1968 Corvette: Service News: Corvette Folding Top Compartment Lid to Folding Top Interference (SN-68-20)

Subject: Corvette Folding Top Compartment Lid to Folding Top Interference (SN-68-20)
Model and Year: 1968 Corvette
Source: Chevrolet Service News
Page Number: NA
Date: April 1968, Volume 40, Issue Number 4

Fig. 12—Remove 1/8" From Lid Stops

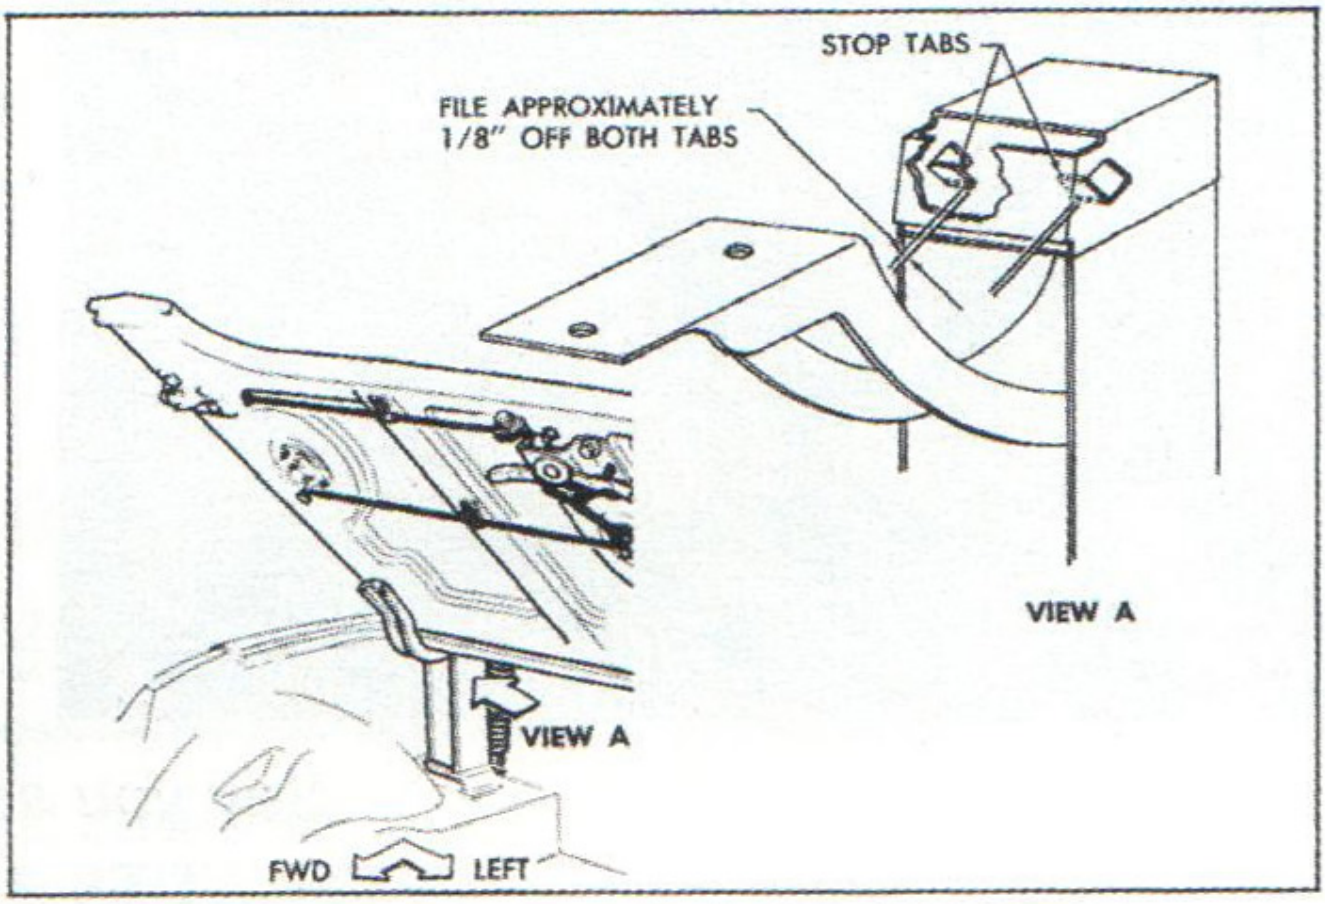
It has been found that the rear compartment lid on some 1968 Corvettes interferes with the convertible top when the top is being raised or lowered. This interference is easily eliminated by filing approximately 1/8" off the existing hinge stops (right and left side). Removing 1/8" from the hinge stops, as shown in Figure 12, allows the rear compartment lid to raise farther thus eliminating the interference condition. The stops referred to are simply tabs that has been punched out of the hinge support members.
